Subject: AP1000 Response to Request for Additional Information (SRP 3)

Response to Request for Additional Information on SRP Section 3

RAI Response Number: RAI-SRP3.8.3-SEB1-03

RAI Response Number: RAI-SRP3.8.4-SEB1-04

Figure SRP3.8.3-SEB1-03-41: RS of Aux. Bldg. Corner of Fuel Bldg. Roof at SB at El. 116.5' Subjected to Enveloped RS in Z Direction

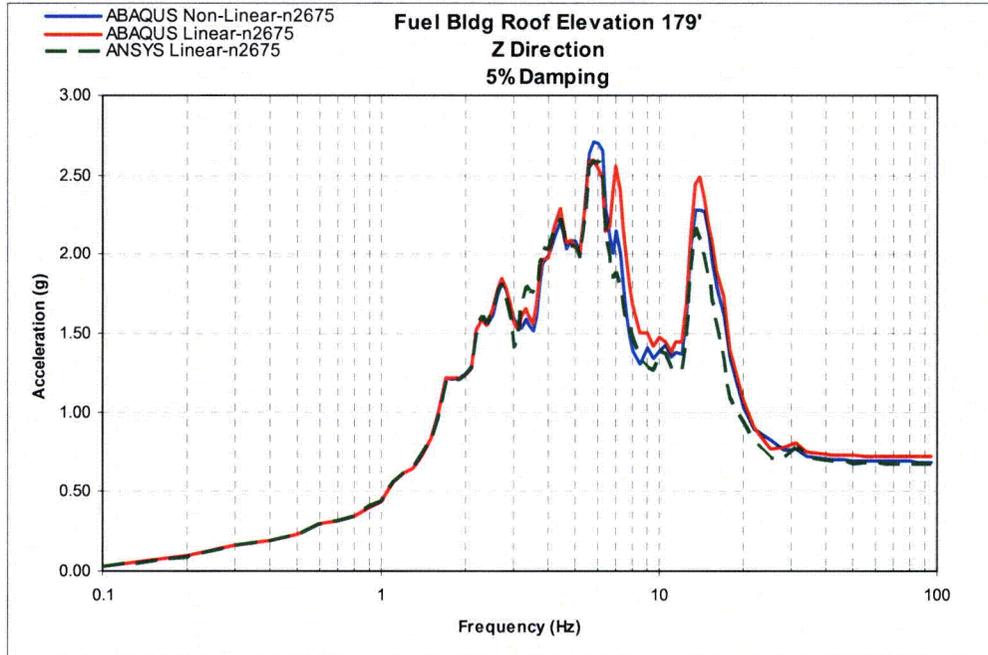
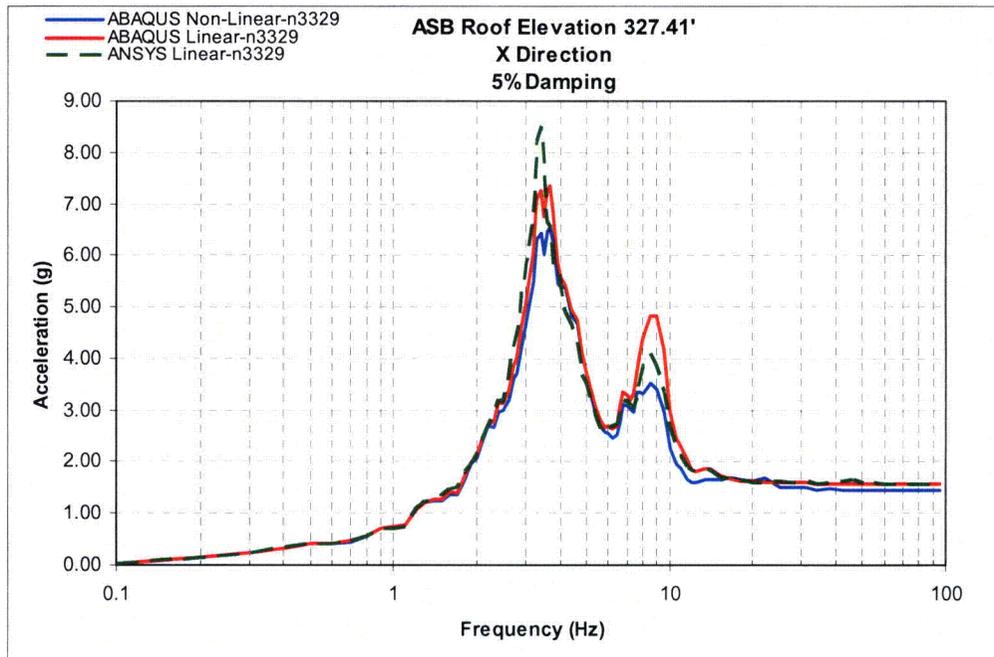
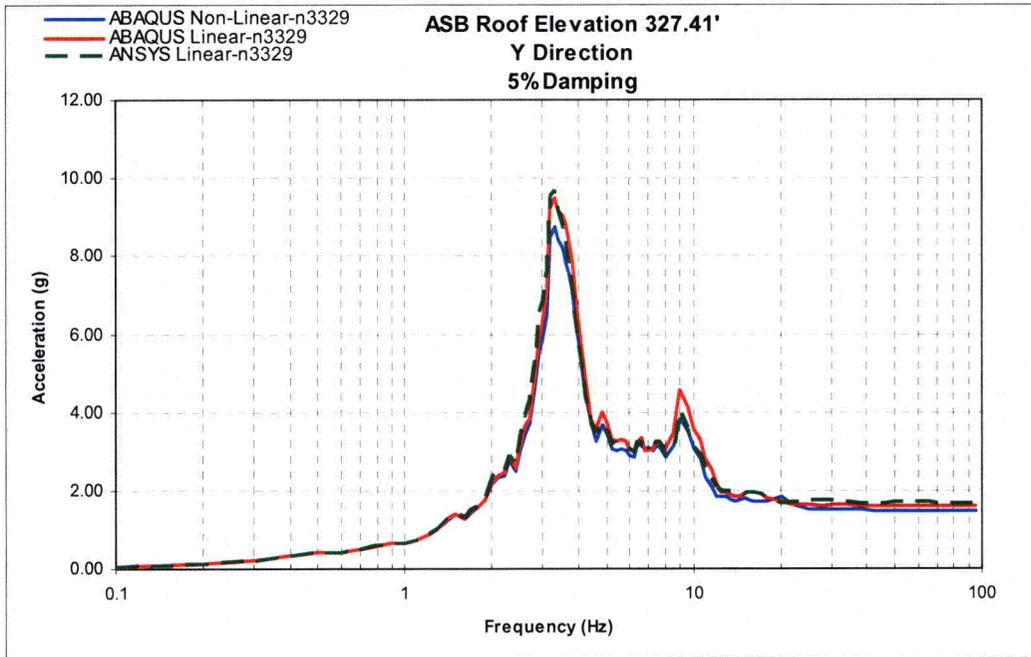
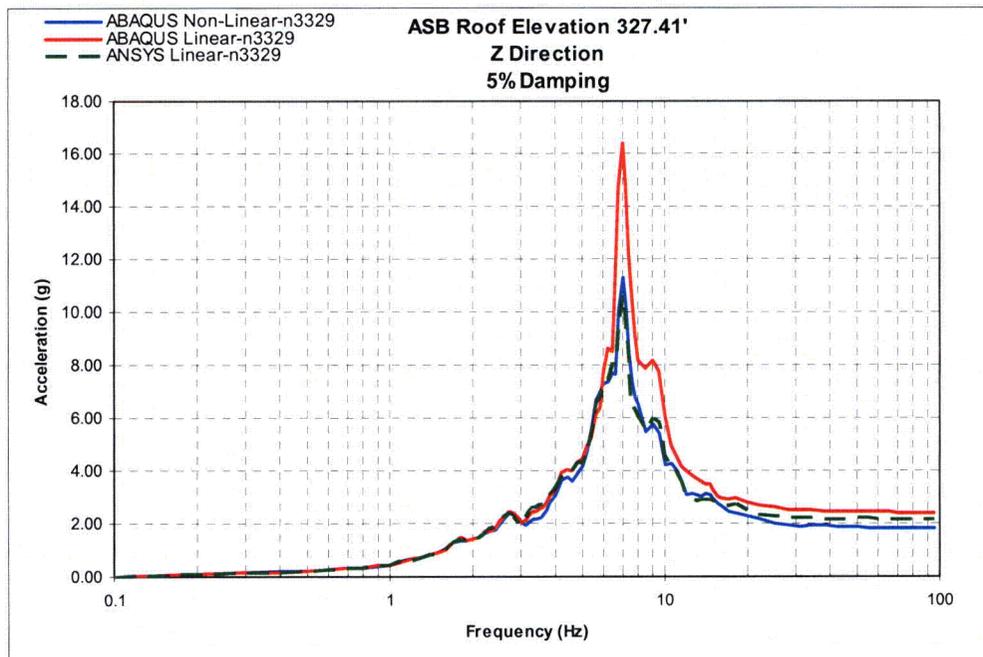
stiffness reduction factor. The staff requests WEC to add the corresponding ANSYS response spectra to Figures RAI-SRP3.8.3-SEB1-03-04 through RAI-SRP3.8.3-SEB1-03-21 in the RAI response, and to discuss any differences between the ANSYS linear results and the ABAQUS linear results. This is needed to ensure the adequacy of the ABAQUS linear model.

The Figures RAI-SRP3.8.3-SEB1-03-04 through RAI-SRP3.8.3-SEB1-03-21 from Revision 2 of this response have been updated to include the ANSYS linear comparison and are presented in Revision 3 Figures RAI-SRP3.8.3-SEB1-03-27 through RAI-SRP3.8.3-SEB1-03-44.

1. A list of critical nodes compared in this analysis is provided in Table RAI-SRP3.8.3-SEB1-01 in the Westinghouse Revision 2 response of this RAI. The FRS comparisons from the previous Revision of this RAI response have been updated to include additional information. These plots now show a comparison between the NI20 ANSYS linear, ABAQUS linear and ABAQUS non-linear models, and are provided in Figures RAI-SRP3.8.3-SEB1-03-27 through RAI-SRP3.8.3-SEB1-03-44.

The minor differences between the ABAQUS and ANSYS results are caused by a combination of the software's element calculation discrepancies as well as modeling modifications made to account for the limitations in FEM programs. The differences in results between the linear ABAQUS and ANSYS models are considered negligible when using the model for structural parametric studies. The FRS comparisons show good agreement up to 10 Hz where most of the structural damage is present. Two differences that affect the results, especially at the higher frequencies, are:

- Alpha Beta Damping - Leads to under damped frequency ranges in the model
- No CIS modeled in ABAQUS

Figure RAI-SRP3.8.3-SEB1-03-45: RC/SC Structural Section in the West Wall

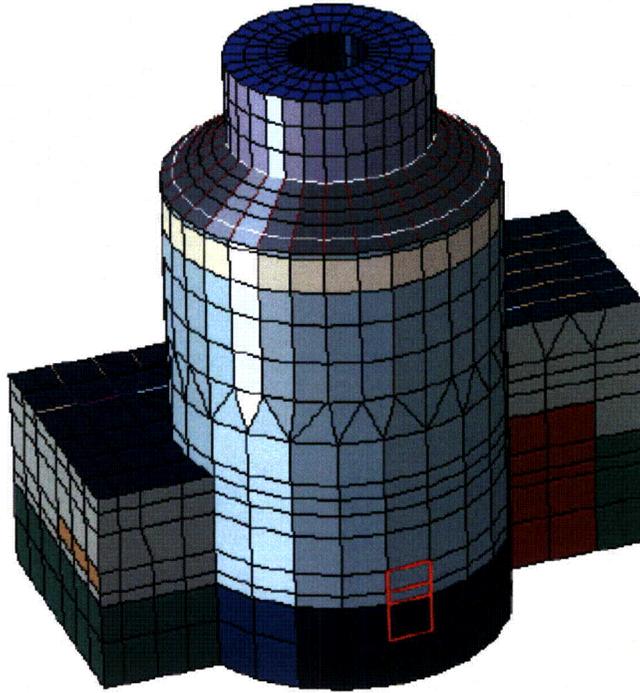
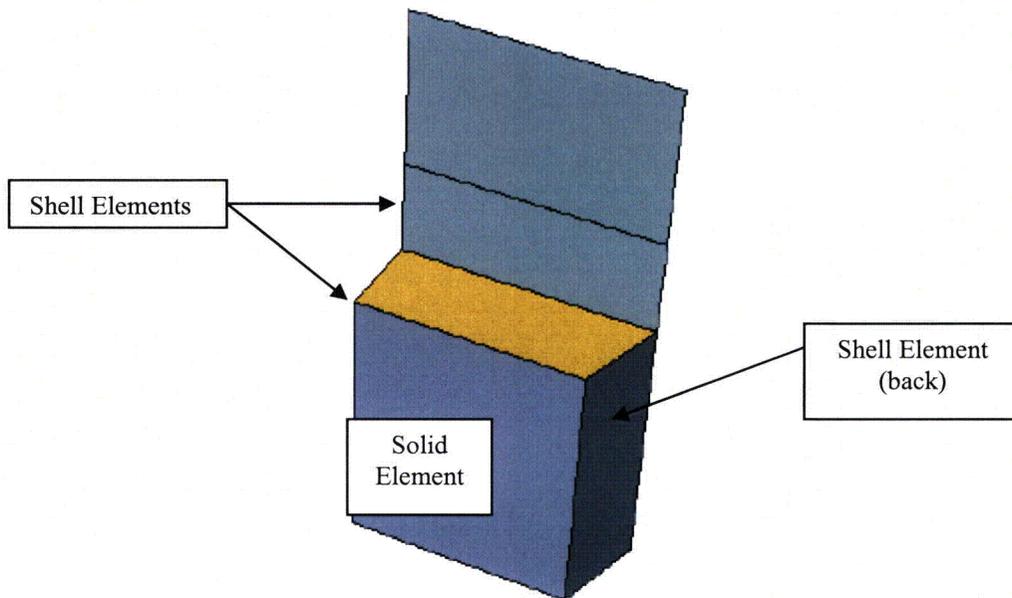
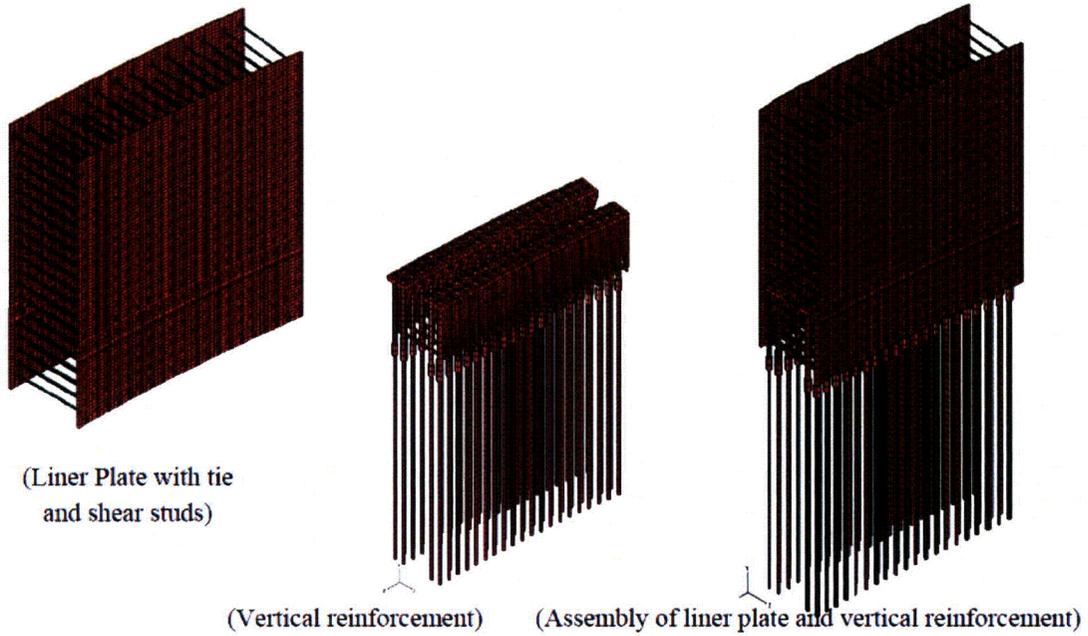
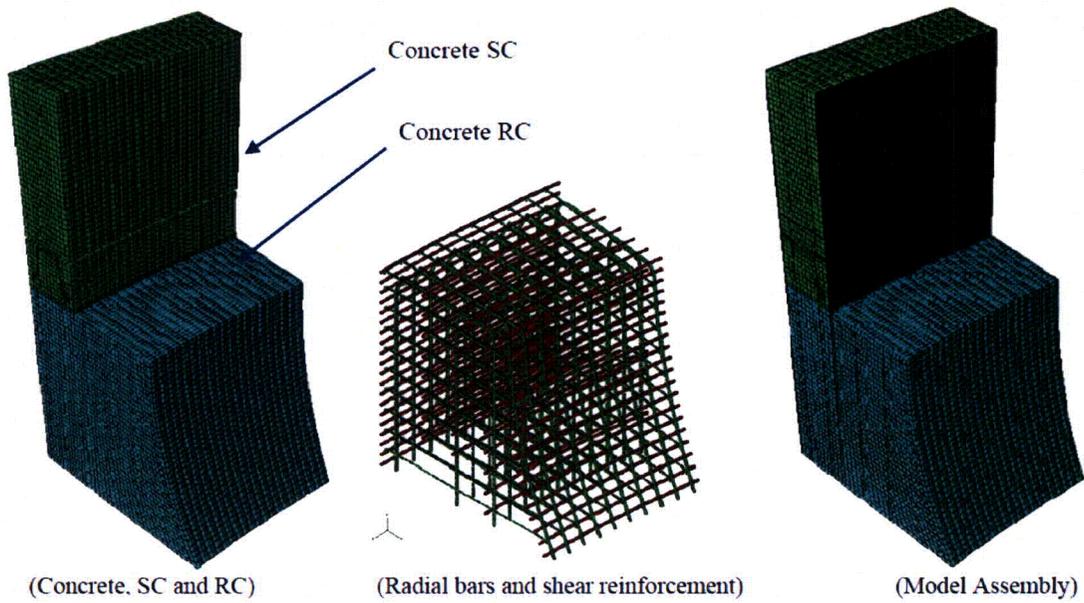
- (a) Describe how the shell elements on both sides of the juncture were modified to match the test results, including how the size difference between the actual connection design configuration and the elements was treated.

- (b) Clarify the statement: "..., with the in-plane shear being the governing case." Were extensional, bending, out-of-plane shear, and in-plane shear behavior of the RC/SC connection all considered? Compare the test stiffness values to the ABAQUS connection model values.

To benchmark the NI20 ABAQUS model with non-linear materials, a section of the West Wall RC/SC connection is selected from the model and given the same loading case as the Level 3 analyses. The section of the model used for this analysis is shown in Figure RAI-SRP3.8.3-SEB1-03-45, with an enlarged view in Figure RAI-SRP3.8.3-SEB1-03-46. The Level 3 in-plane analyses use a detailed finite element model which includes tie bars and reinforcement steel within the steel composite structures, shown in Figure RAI-SRP3.8.3-SEB1-03-47 and RAI-SRP3.8.3-SEB1-03-48. This provides very accurate model representation and benchmarked materials. The Level 1 analyses do not model the reinforcement because of the model refinement and are therefore inherently weaker than the actual structure. An in-plane shear load is applied to the model and analyzed as an explicit time based displacement load for both Level 1 and Level 3 analyses.

The Level 1 model contains three shell geometries and one solid geometry used to represent reinforced concrete, steel-composite, and modeling aids used to transfer forces between solid and shell elements. In order to benchmark the NI20 model, the stiffness of the interface shell elements, used to transfer the wall element moments to the solid elements in the basemat, were changed to match the in-plane behavior of the more detailed model. These properties were modified to show the failure in the Shield Building wall elements occurred before the CIS reinforced concrete, which match the Level 3 analyses. The non-linear concrete and SC material properties of the shield building wall and CIS base were not modified.
